SUBJECT: ISSUANCE OF AMENDMENT (TAC NO. M83180)

The Commission has issued the enclosed Amendment No.158 to Facility Operating License No. DPR-65 for Millstone Nuclear Power Station, Unit No. 2, in response to your application dated April 16, 1992, supplemented by letter dated May 7, 1992.

The amendment changes the Millstone Unit No. 2 Technical Specifications by modifying the existing two region spent fuel pool design, modified by Amendment 109, dated January 15, 1986, and Amendment 128, dated March 31, 1988, to a three region configuration.

Amendment No. 158
License No. DPR-65

FIGURE 3.9-1 MINIMUM REQUIRED FUEL ASSEMBLY EXPOSURE AS A FUNCTION OF INITIAL ENRICHMENT TO PERMIT STORAGE IN REGION C

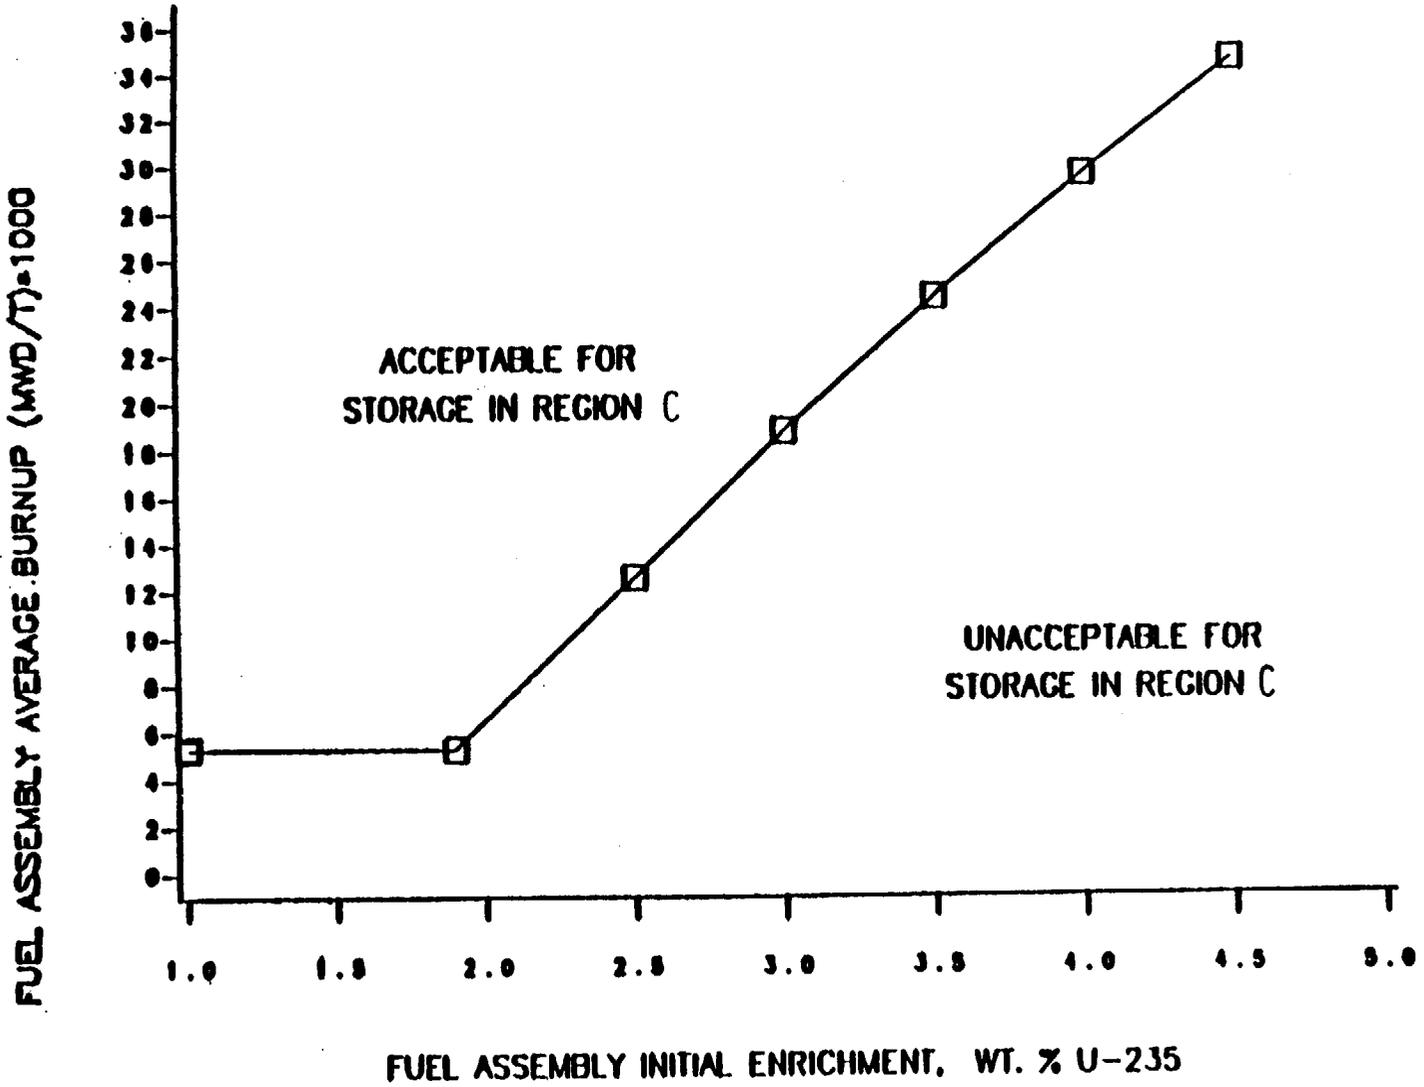
- (1) Definition 1.39, STORAGE PATTERN is currently defined for Region II. This is being changed to define the three-out-of-four array to be used in Regions B and C.
- (2) TS 3.9.17 is currently concerned with fuel movement over Region II racks (due to the dropped assembly accident and misplaced fuel assembly event). This is being changed from any fuel movement over the Region II racks to any fuel movement in the spent fuel pool.
- (3) TS 3.9.18 is being modified to change the wording in the surveillance requirements from Region II to Region C, and adds a surveillance requirement to ensure that fuel assemblies to be placed in Region A are within the enrichment and burnup limits of a new Figure 3.9-4.
- (4) Figure 3.9-1 is being modified to change the references from Region II to Region C.

FIGURE 3.9-2

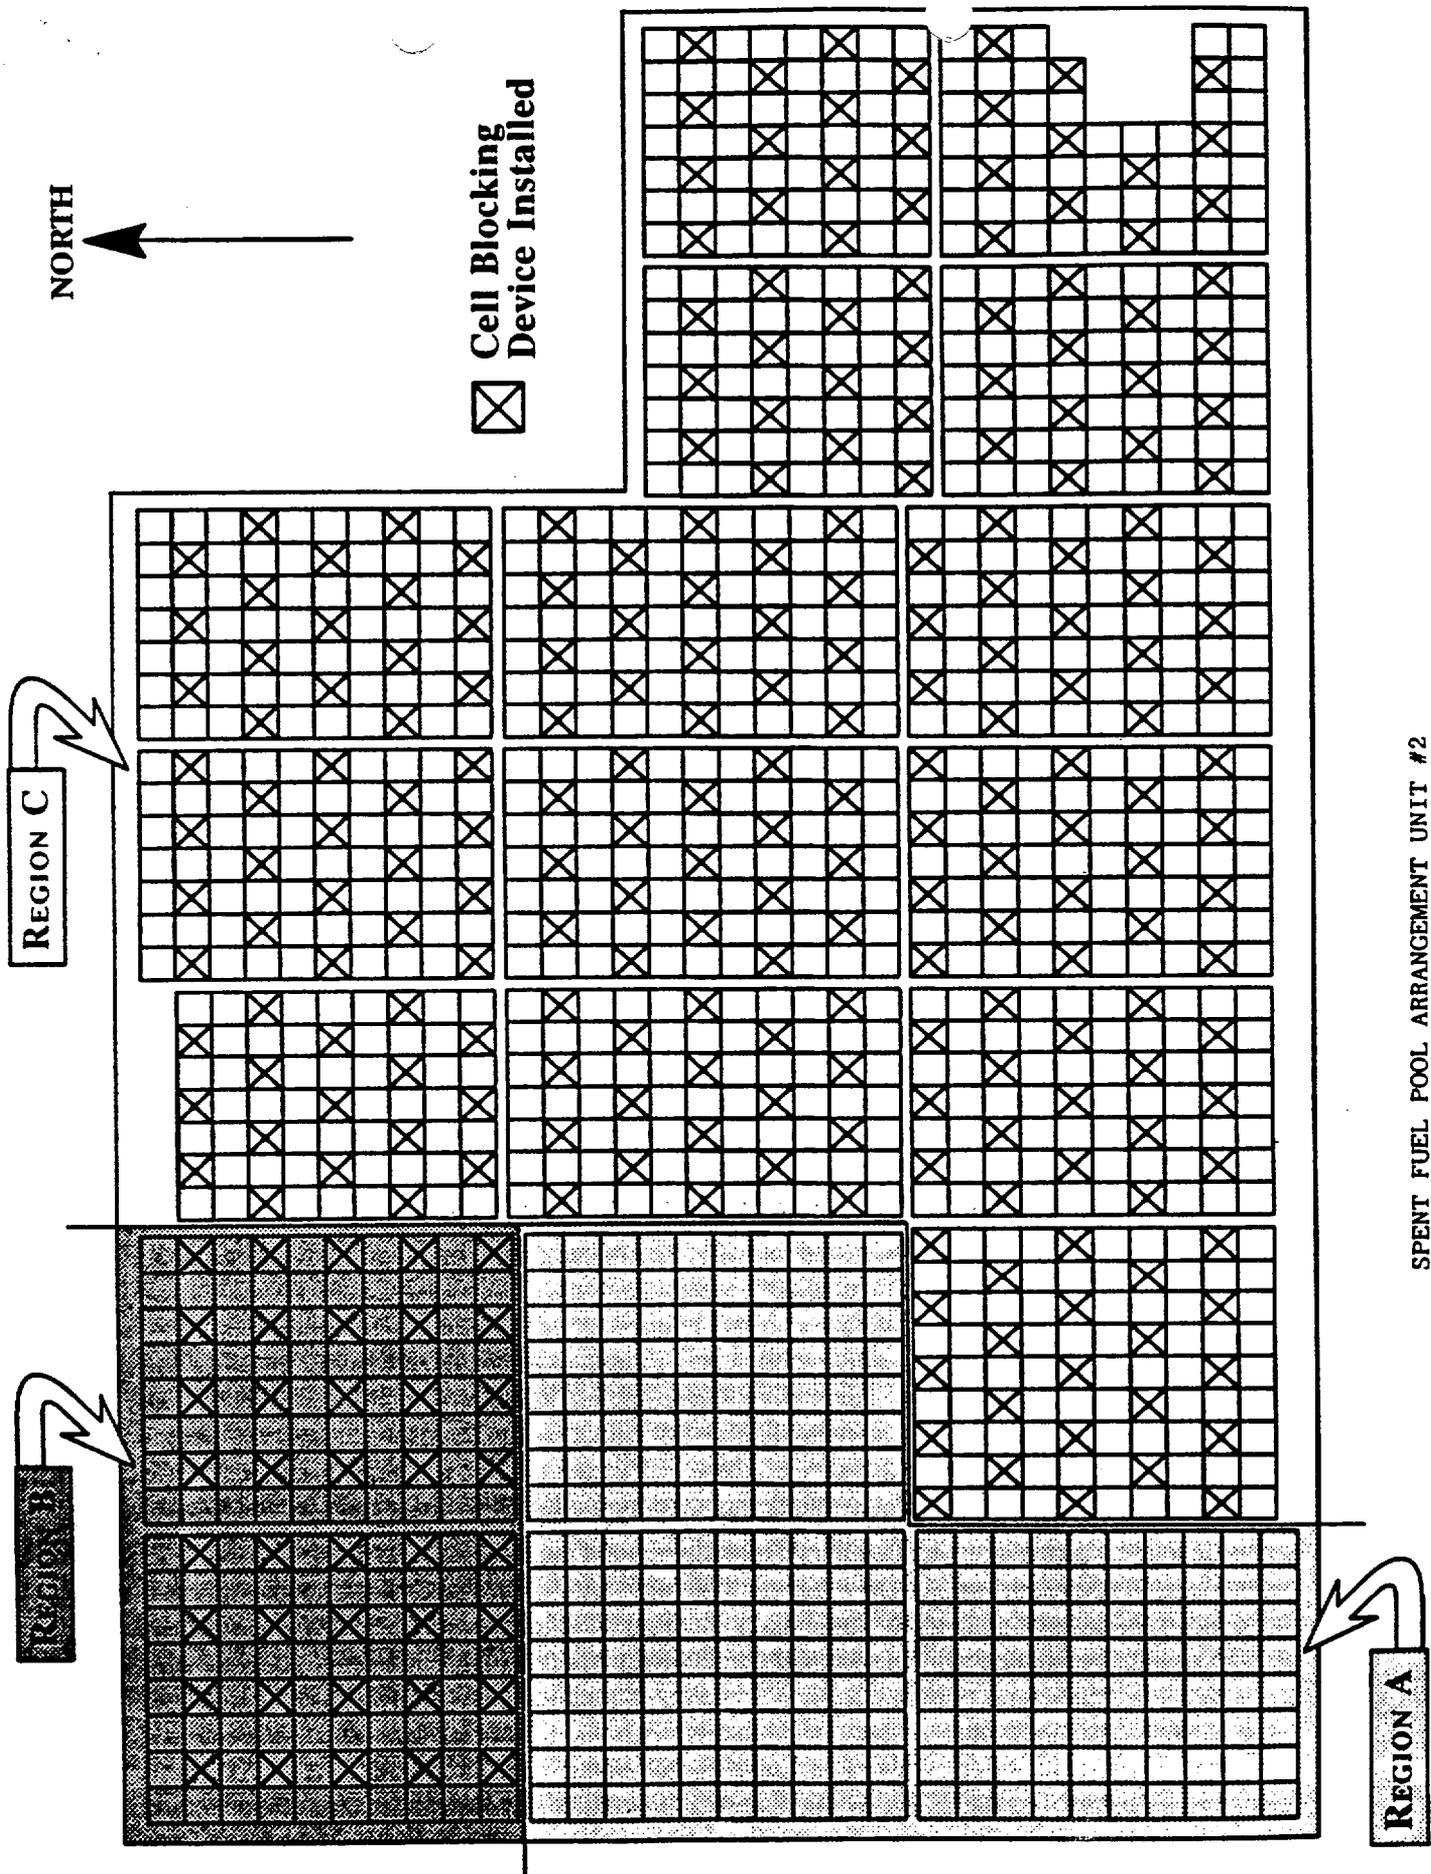
- (5) Figure 3.9-2 is being modified to delete the references from Regions I and II and add Regions A, B, and C.
- (6) Figure 3.9-3 is being modified to change the references from Region II to Region C.

FIG. 3.9-4 MINIMUM REQUIRED FUEL ASSEMBLY EXPOSURE AS A FUNCTION OF INITIAL ENRICHMENT TO PERMIT STORAGE IN REGION A

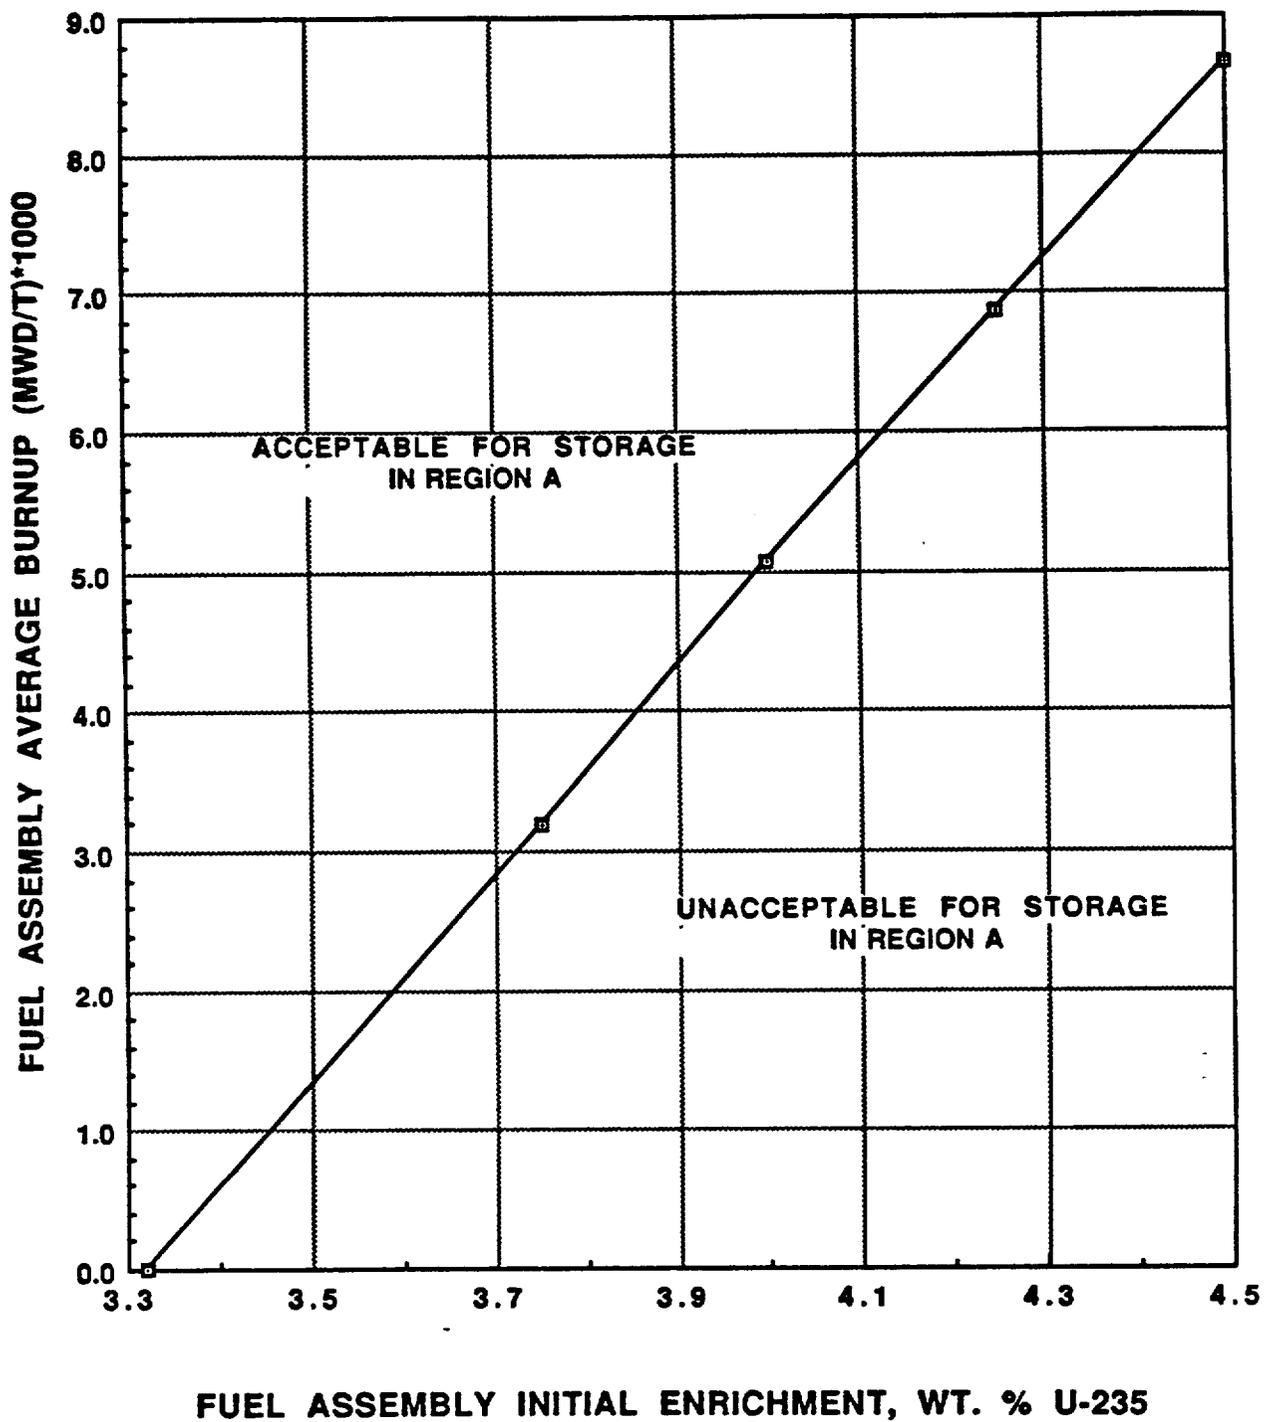
The old Region I rack design was also reanalyzed utilizing all of the cells in a four-out-of-four cell arrangement with credit for fuel burnup (new Region A designation). The same Boraflex gap distribution assumed in the Region B analysis was used. As seen from TS Figure 3.9-4, fuel with an initial enrichment of 4.5 w/o U-235 and minimum burnup of 8670 MWD/MTU is equivalent to unirradiated fuel enriched to 3.3 w/o U-235. The resulting maximum (95/95) k-eff was 0.9317 for ANF fuel, 0.9381 for Westinghouse fuel, and 0.9335 for CE fuel, all within the 0.95 limiting criterion.

- (7) A new Figure 3.9-4 is being added to specify the allowable enrichment and burnup limits for fuel assemblies to be stored in Region A.
- (8) TS 3.9.19 is being split into two parts:
